In the Matter of
Commonwealth Edison Company
(Braidwood Nuclear Power Station, Units 1 and 2)
Docket Nos. 50-456 and 50-4570L

Enclosed please find the NRC Staff material concerning the calculation of the probability of occurrences for rail car explosion which you requested in the May 17, 1985 deposition of Mr. Charles M. Ferrell, Tr. 75-76. These are the work papers of Dr. Jacques Read dealing with construction permit stage analyses performed by the NRC Staff.

METHODS OF COMPUTING BRAIDWOOD RAILROAD ACCIDENT PROBABILITY

LENGTH OF TRACK AT VARIOUS CUMULATIVE HAZARD LEVELS
AS A FUNCTION OF NUMBER OF BOXCARS SIMULTANEOUSLY
DETONATED

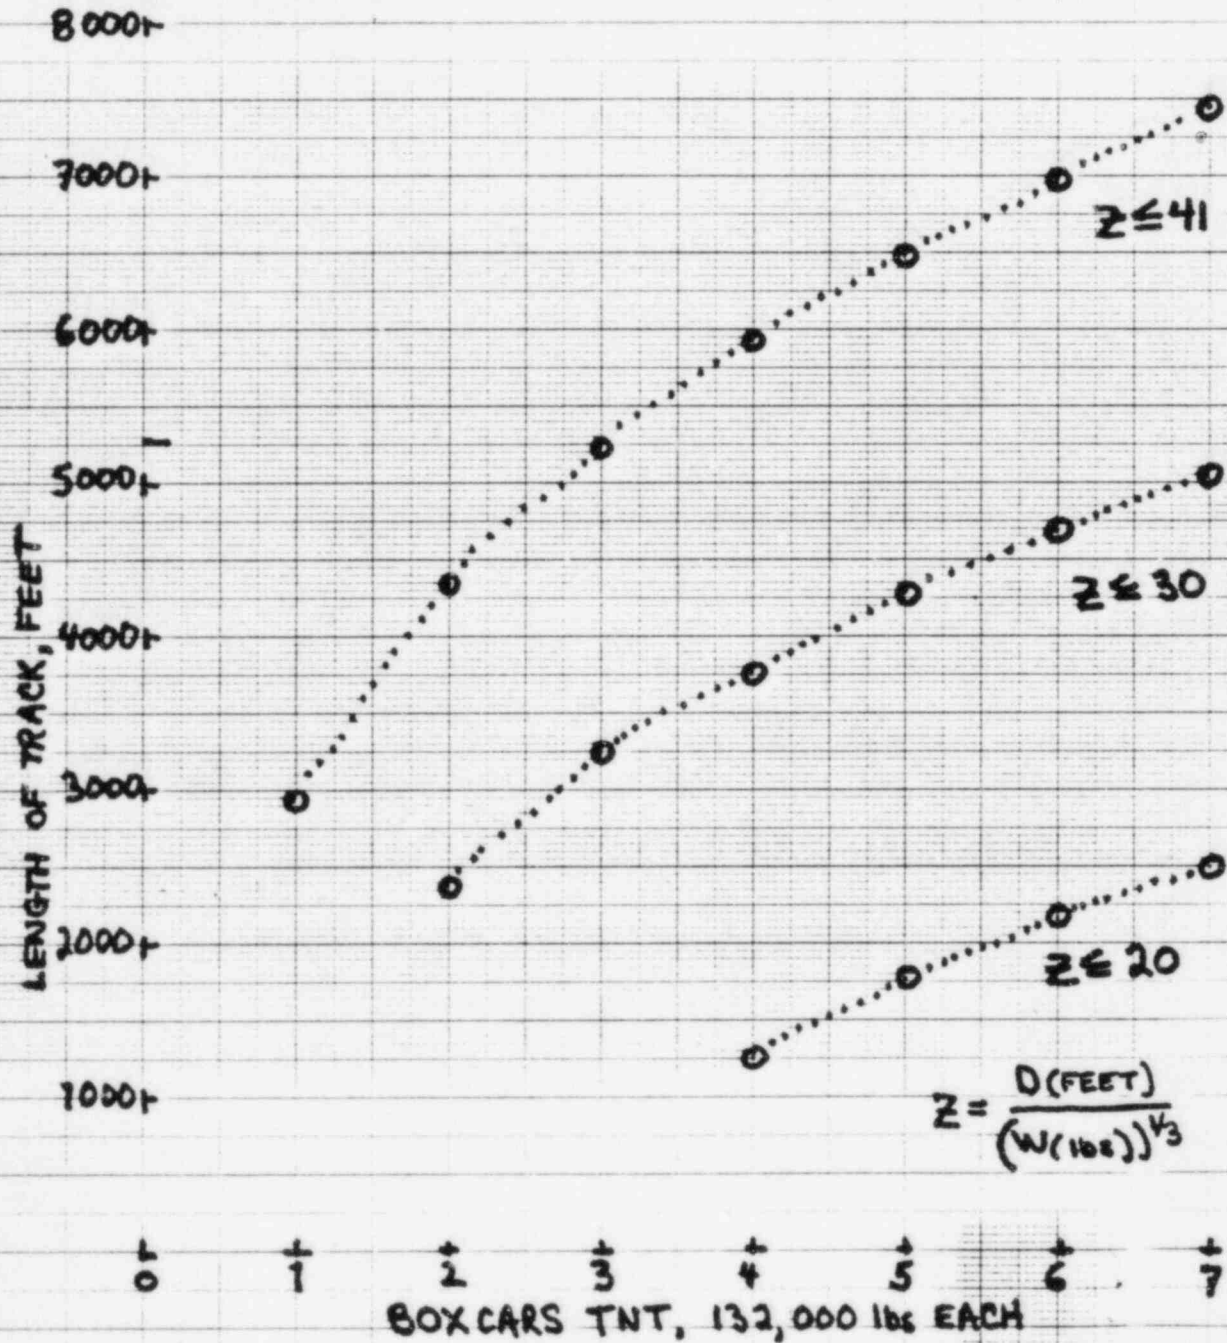
Shipments of explosives are limited to seven or fewer boxcars of flake TNT per train by the size of the loading facilities at the Joliet Army Ammunition Plant. Actual shipping practice can be affected by cyclical munitions needs, boxcar availability, railroad rate structure, safety considerations, and the division of work among the many Army arsenals, such that any number of boxcars of TNT within the possible range may appear in a given freight train on a given day.

The commonly accepted method of comparing damaging effects of explosions is the "scaled distance", which is defined as the distance in feet between the explosion and the structure in question, divided by the cube root of the weight of the charge in pounds of TNT equivalent. For comparison, the table below lists cumulative track length on which the explosion must occur to yield less than a given scaled distance, assuming a 1500 foot track-plant closest approach, and two possible shipment sizes, 10^6 lbs and 3×10^5 lbs.
